HIGH DENSITY INTERCONNECT
9 CHIP BARREL HDI
BONDING DIAGRAM

SCALE	FILMED	DRAWING NUMBER	Sheet 1 of 2	REV.
		3823.112-MB-330190		F

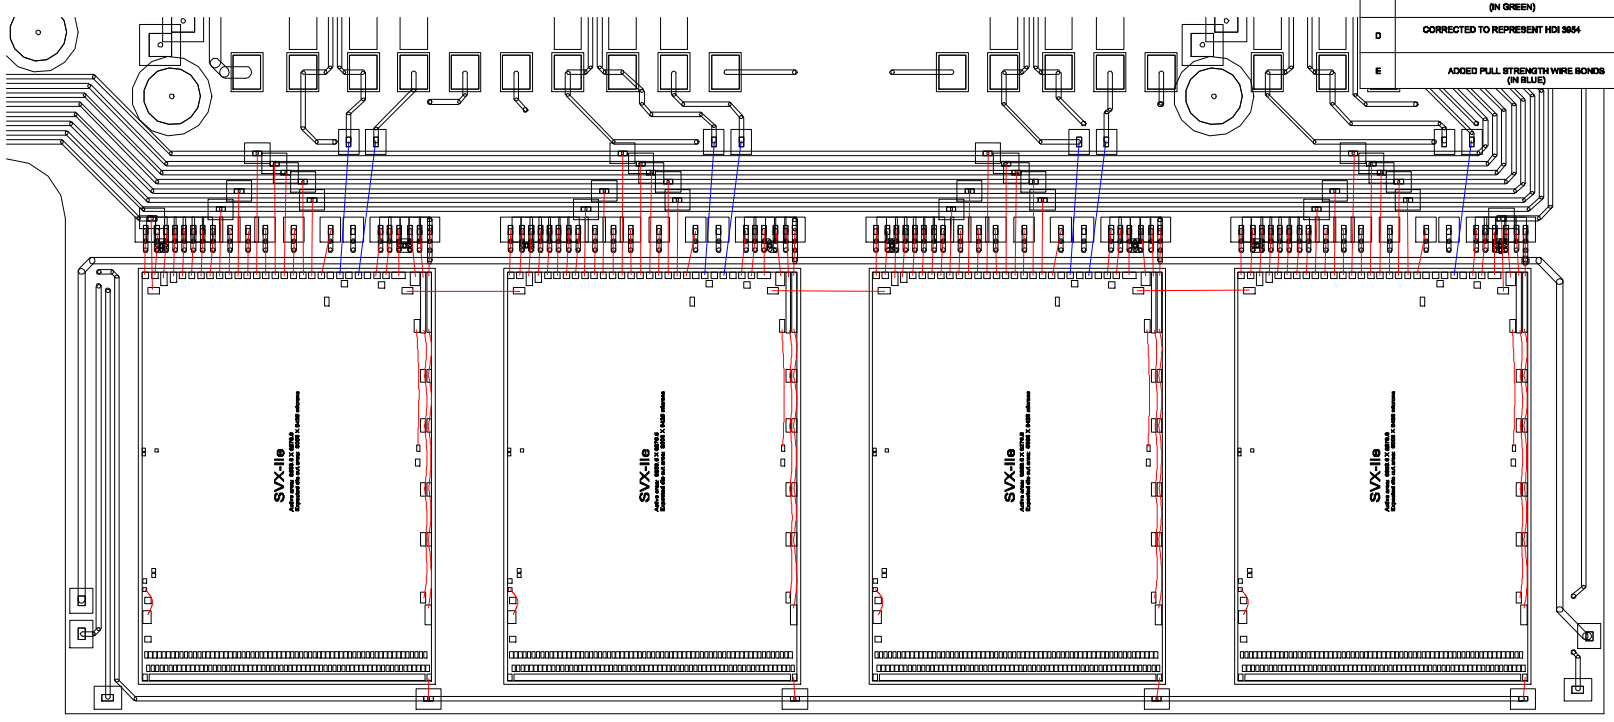
REV.	DESCRIPTION	DRAWN / APPD.	DATE
C	INDICATE POSITION OF 4 CIRCUIT CORRECTION WIRE BONDS (IN GREEN)	MATULIK	02/04/99
D	CORRECTED TO REPRESENT HDI 3954	MATULIK	03/11/99
E	ADDED PULL STRENGTH WIRE BONDS (IN BLUE)	MATULIK	01/11/00

REV.	DESCRIPTION	DRAWN / APPD.	DATE
F	REMOVED ONE PULL STRENGTH WIRE BOND DUE TO UNPLATED HDI PAD.	MATULIK	03/15/00
